Field campaign

Topic	GTC hood ram – cover deletion (SC14/13)
Market area	United Kingdom E01 Bentley UK (6E01), Germany E02 Bentley rest Europe (6E02), United States E05 Bentley USA and rest America (6E05)
Brand	Bentley
Transaction No.	2037493/3
Campaign number	EA13
Note	
Type	Service campaign
US code

New GTC

Figure 2

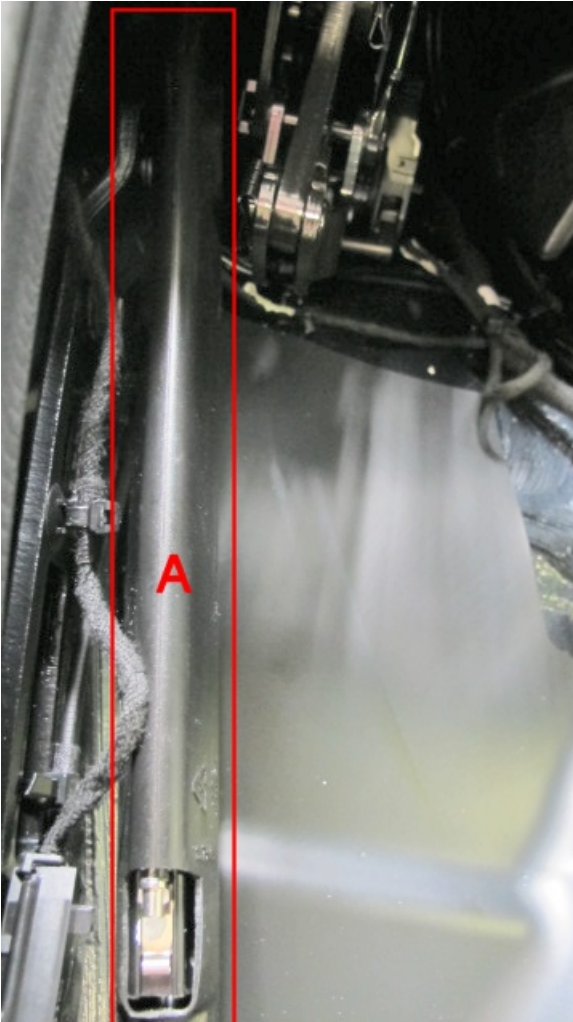
2. Identify the plastic cover 'A' fitted to the tonneau ram (see Figure 2)

Figure 3

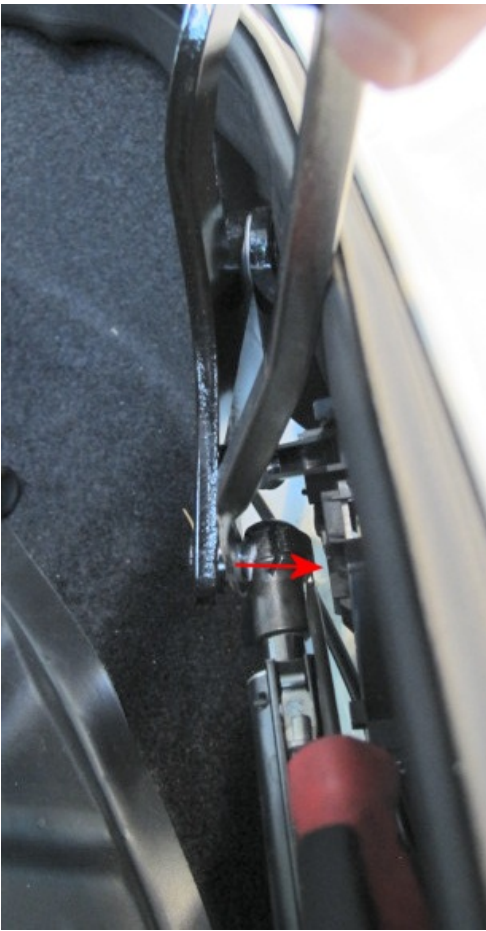
3. Partially release the ram ball end retaining clip before releasing the ram from the ball end pin (see Figure 2)

Figure 6

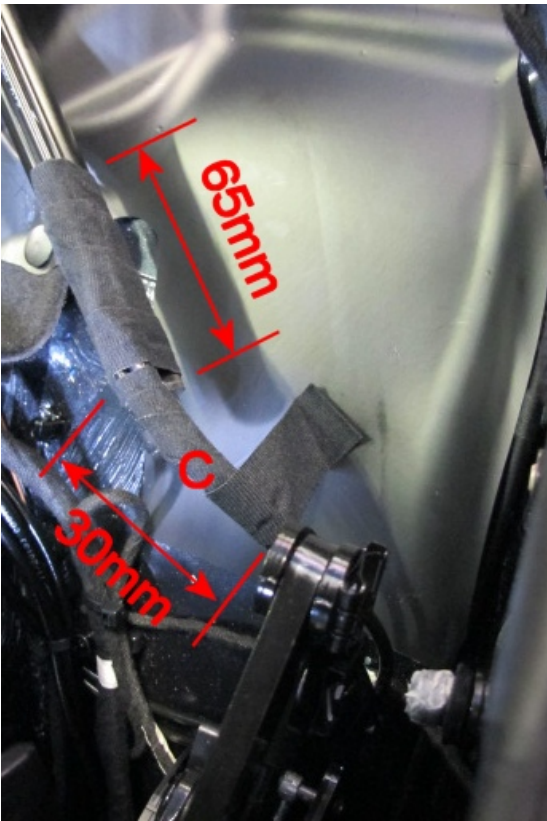
6. Apply anti-creak tape to the ram, enclosing the two hoses and tape up to but not over the ball pin receiver 'B', approximately 65mm of the ram (see Figure 6).
